Check procedure of opening device and door alignments

The models involved in this issue are MW-32 BIS, MW-32 BIT and MC-32 BIS.

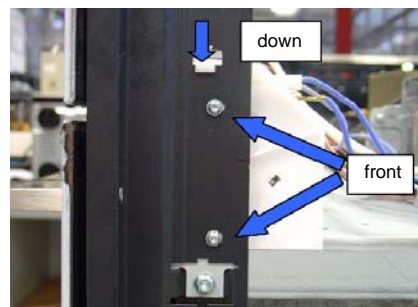
It has been noticed on the first productions of the new compact microwave ovens range manufactured in the factory of Teka Portugal that it may happen that some problems with the door micro switches holder and with the door alignment can occur. These problems are debt to the wrong fixing position of the holder that finally causes that, even when the door is closed, the switches are not pressed and, obviously, the appliance does not work and to strong movements during transport.

Note!

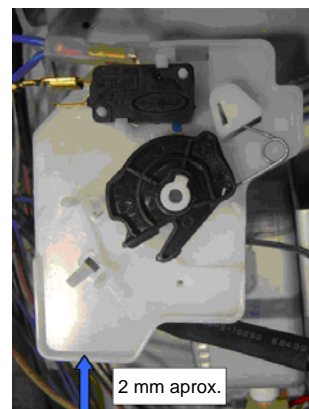
It has been noticed that sometimes, using the new redesigned holders the problem appears after some uses or after a long cooking with the grill element working. It is due to the expansion of the metallic shield of the oven that presses on the switches holder and makes it loosing the position. In that case, it is necessary the reduction on the lower side, in contact with the upper shield of the oven body, sanding or cutting and making it 2 mm aprox. shorter
